Pneumatic System Manifolds

1 Supply Challenge

Figure 1

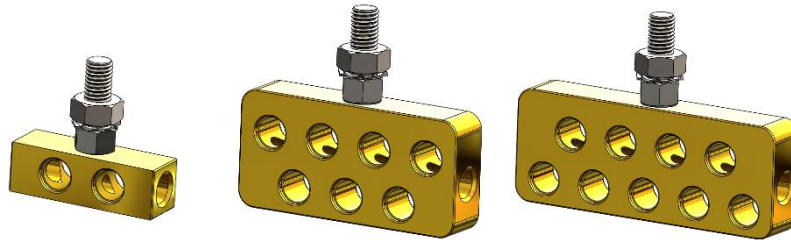
4-port, 14-port, and 18-port manifold alternate designs are shown in Figure 1. Table 3 shows the expected price impact of machining these alternative manifolds.

Figure 2

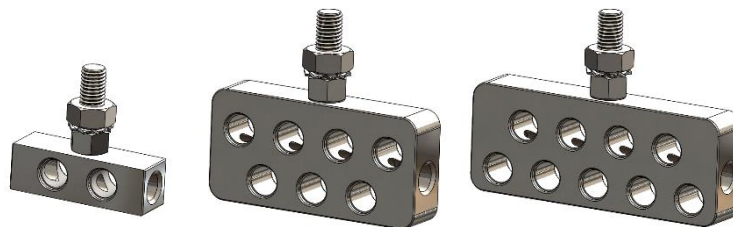
The price increases associated with option 3.2 are significant for the 14-port and 18-port manifolds. An alternative would be to make the blocks from stainless steel as shown in Figure 2. Table 4 shows the expect price impact of these manifolds in stainless steel.

Figure 3

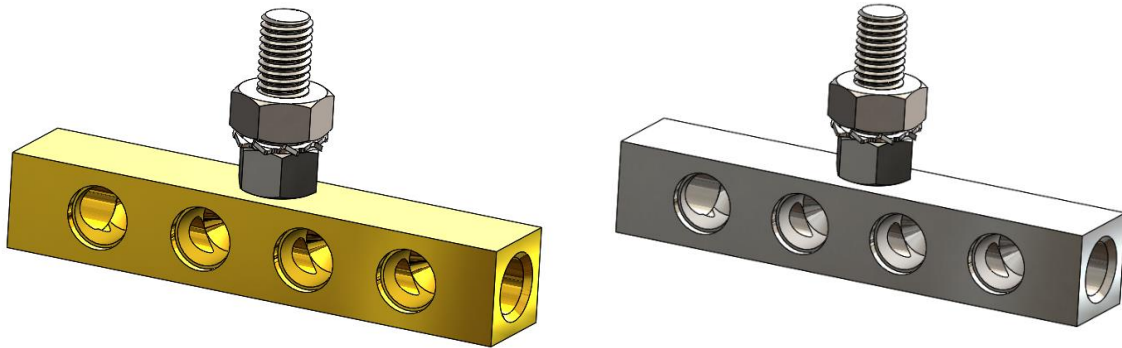
It may be that the 4-port manifold suggested in options 3.2 and 3.3 are not feasible because all four injectors must be oriented in the same direction for an installation. In this case a final alternative is suggested as shown in Figure 3 in both brass and stainless-steel variants. Table 5 shows the expected price impact for these manifold options.
